DESIGN/PROCESS CHANGE NOTIFICATION

DNP013		
--------	--	--

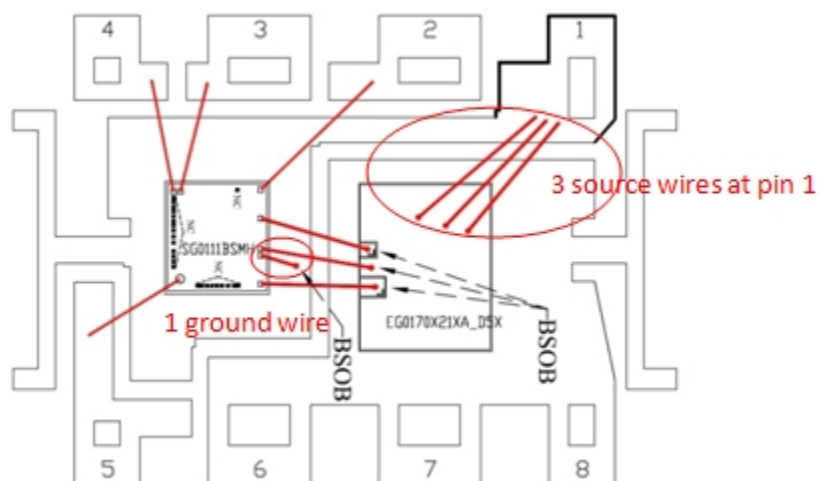
Description of Change (From) :

Current bond layout is having one ground wire and three sources wires at pin 1

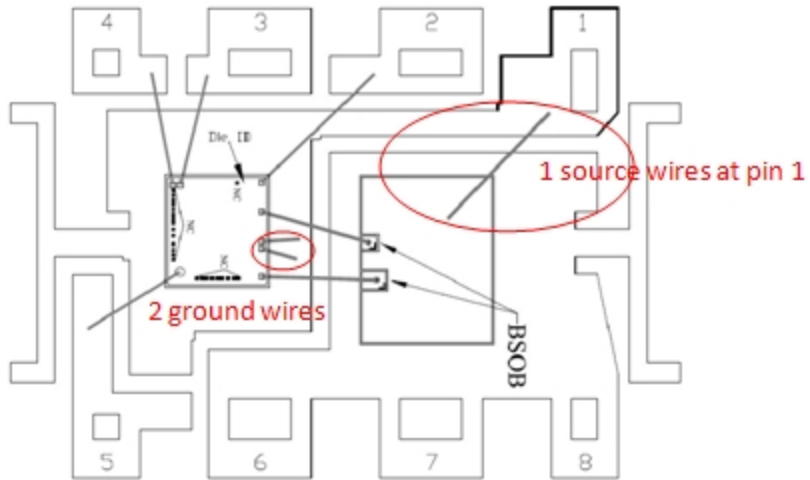
Description of Change (To) :

New bond layout is having two ground wires and only one source wire at pin 1.
